ST. CHARLES SINCE 1834	**PLAN COMMISSION AGENDA ITEM EXECUTIVE SUMMARY**			
	Project Title/Address:	Concept Plan for Hillcroft Townhomes		
	City Staff:	Ellen Johnson, Planner		
	PUBLIC HEARING 5/5/15		**MEETING 5/5/15**	X
APPLICATION:		Concept Plan		
ATTACHMENTS AND SUPPORTING DOCUMENTS:				
Staff Report		Plan documents		
Concept Plan Application, received 4/3/15

Staff Report

RE: Hillcroft Townhomes Concept Plan

Project Name: Hillcroft Townhomes, 1147 Geneva Rd. – Concept Plan

PRELIMINARY SITE PLAN

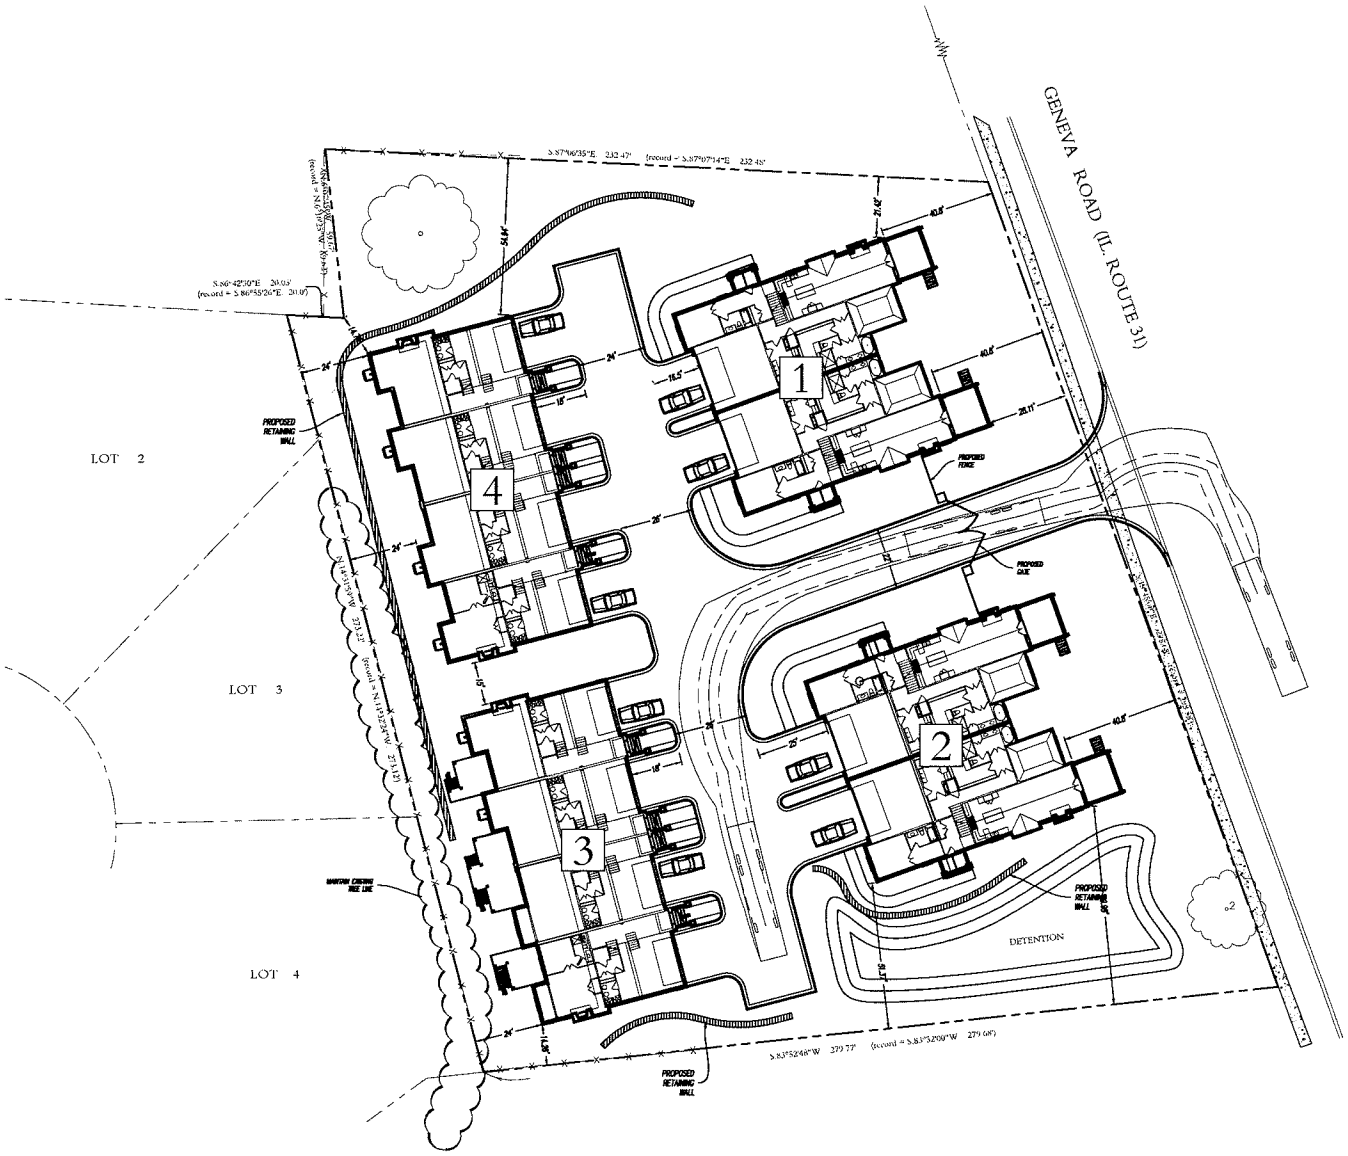
- As proposed, the development does not conform to the lot width, building height, or rear yard requirements in the RM-1 District. Deviations from these requirements could be granted through a Planned Unit Development (PUD).

- The access point off of Geneva Rd. will be moved to the north and will run between buildings #1 and #2. Because Geneva Rd. (Rt. 31) is a state highway, an IDOT permit will be needed for any work done in the right-of-way.
- Parking will be located at the center of the site, between the two sets of buildings. Garages will be rear-loaded for Buildings #1 and #2 will front-loaded for Buildings #3 and #4.
- A landscape plan will be required as part of the PUD Preliminary Plan. A landscape buffer will be required along property lines adjoining the RS-3 zoning district (north and west property lines). The site plan indicates that the existing tree line along the west

property line will be maintained. Additional landscaping to meet the buffer requirements provided in **Section 17.26.070 Landscape Buffers** will be required. These requirements include opaque, year-round screening to a height of six (6) ft. by means of berming, landscaping, fencing, and/or decorative walls (along the north and west property lines).

- The parking stall length shown for the northern unit of Building #1 is shown as 16.5 ft. **Section 17.24.070.B Design of Off-Street Parking Facilities** requires 18 ft.
- A gate is proposed at the entrance drive. The gate would need to default to open in the event of a power outage. The gate would also need to gain approval of the Fire Chief and the Police and Fire departments would need the access code. The gate may also be a concern for Public Works to access public utilities located between the buildings and for monthly electric and water meter reading.
